**PLANNING BOARD
STAFF REPORT
September 21, 2023**

Site Plan Review

APPLICANT: Angelo Ingrassia, 58 S Main Fairport, LLC
PROJECT ADDRESS: 58 South Main Street
ZONING DISTRICT: B-1 Business District, Design Overlay District
SECTION OF CODE: Chapter 550 Article VI; Article IX

Re: 58 South Main Street – Site Plan Review

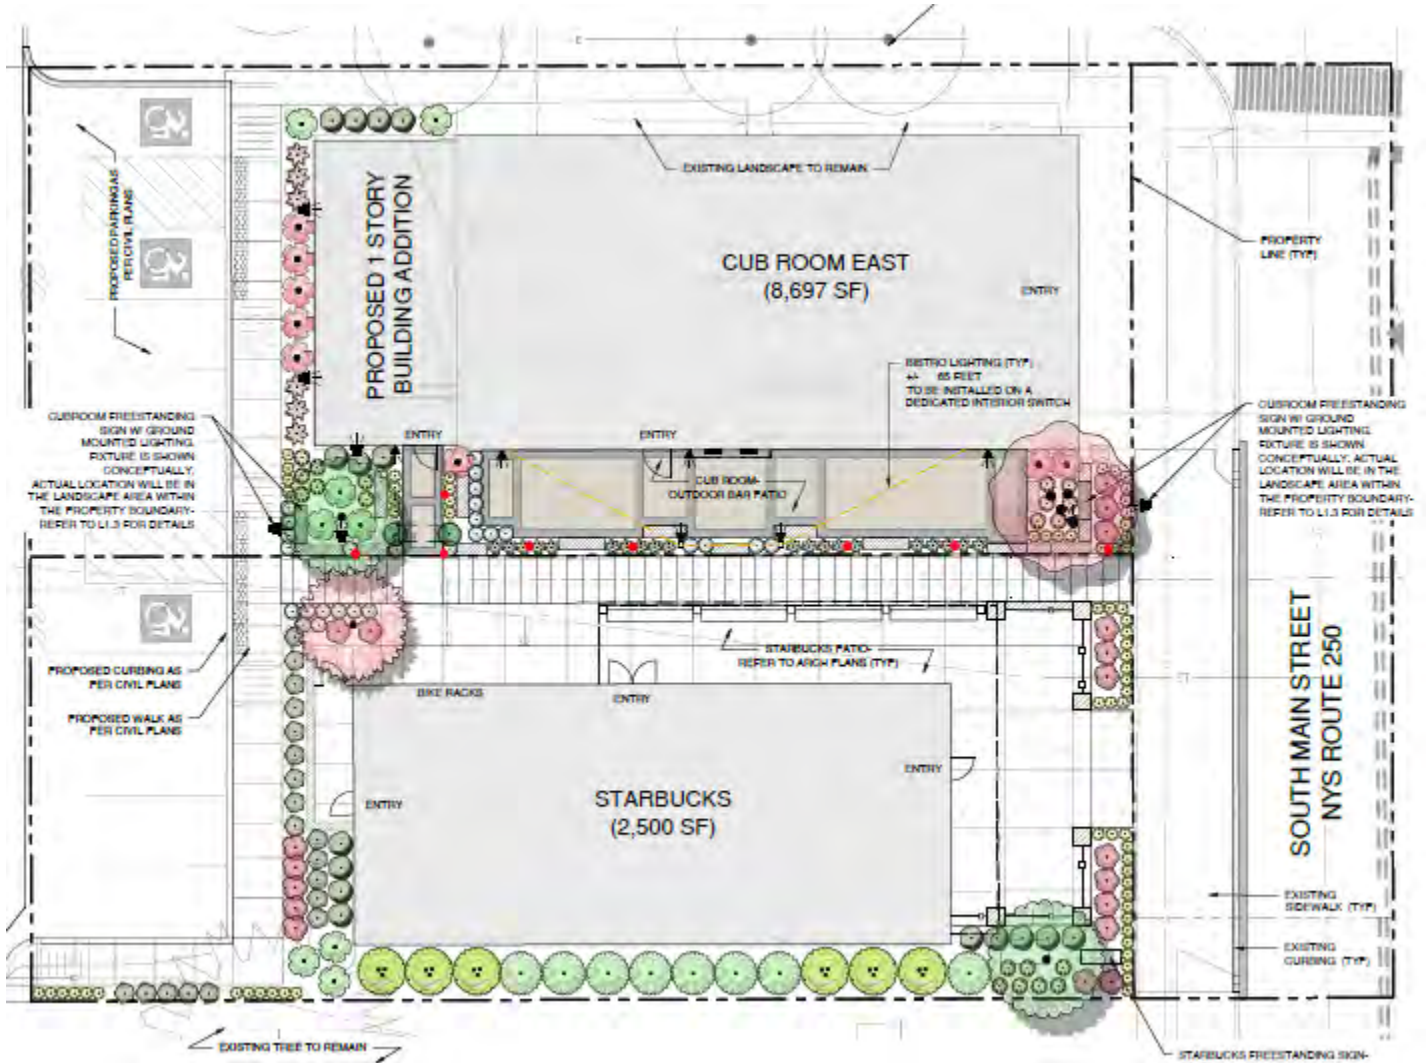
The existing building (Bank of America) does not meet the width to height ratio as the width of the building is 40' and the height of the building is 35' 6".

The proposed building does not meet the width to height ratio. The width of the proposed building is 33' and the height is 24' 9".
